## SERVICE BULLETIN MAINTENANCE OF WAY EQUIPMENT

**DATE:** 12-18-2001 **BULLETIN NO:** 01-018

**TITLE:** WORKHEAD POSITION CYLINDER ORIFICES SERVICE GROUP

**PRODUCT SERIES / MODEL:** 6700S TAMPERS

FIGURE 1  
WORKHEADS

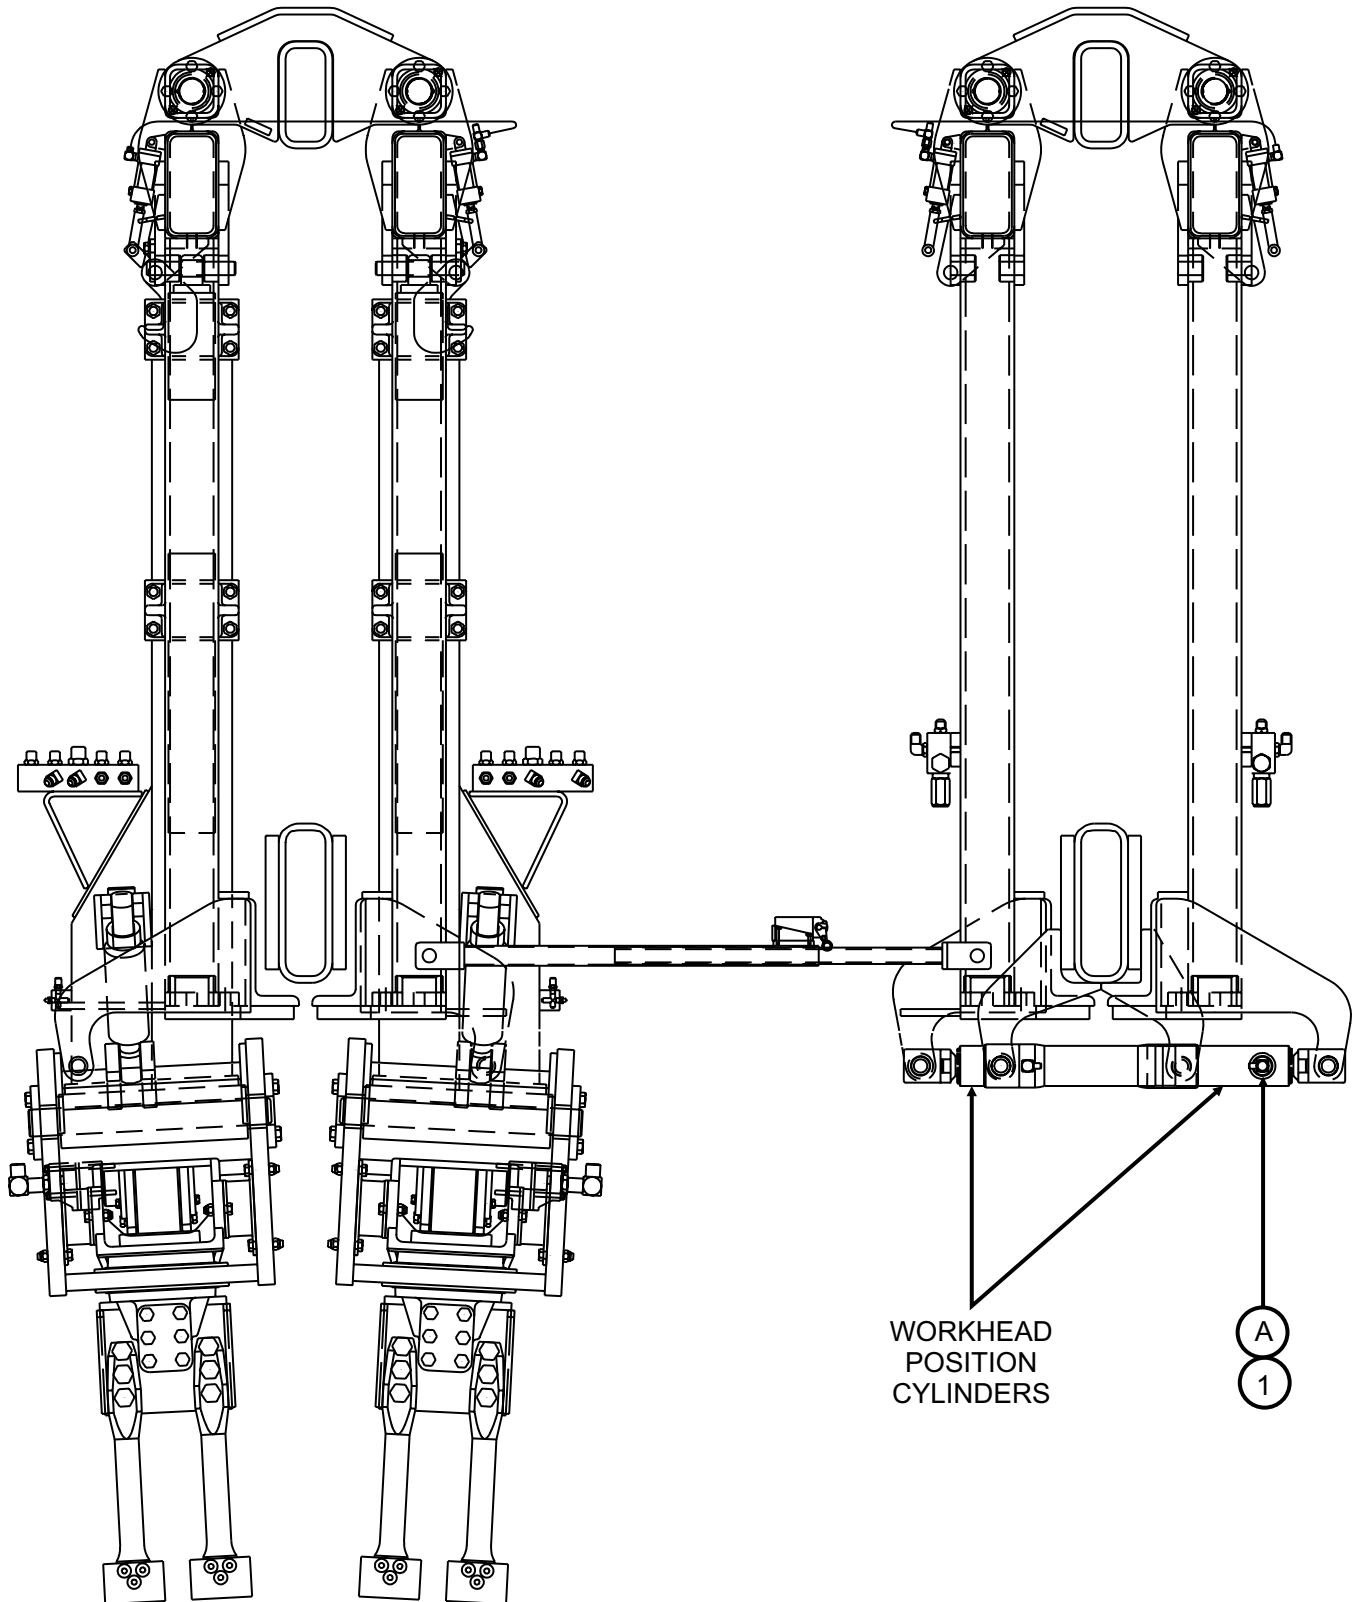
**SUMMARY:** There are times when the workhead position cylinders cannot hold the extended position when the machine is working or traveling down the track. This condition exists when the cylinder is being extended and stopped in mid stroke. An orifice has been added in the rod end hose fitting to eliminate cavitation in the rod end of the cylinder.

**SERVICE GROUP INSTALLATION - See Figure 1**

1. Disconnect the hydraulic line from the existing adapter fitting (A) in the rod end port of all four workhead position cylinders.
2. Remove the existing adapter fitting (A) from the rod end port of all four workhead position cylinders.
3. Install a new orifice adapter fitting (1) in the rod end port of all four workhead position cylinders and tighten securely.
4. Reconnect the hydraulic line to the new orifice adapter fitting (1) in the rod end port of all four workhead position cylinders and tighten securely.
5. Start the engine and pressurize the workhead position cylinders circuit.
6. Check the hydraulic lines and new orifice adapter fittings for hydraulic leaks.

- Disconnecting the hydraulic lines from the workhead position cylinders rod end ports.
- Removing the existing adapter fittings from the cylinders rod end port.
- Installing the new orifice adapter fittings in the cylinders rod end port.
- Reconnecting the hydraulic lines to the new orifice adapter fittings.
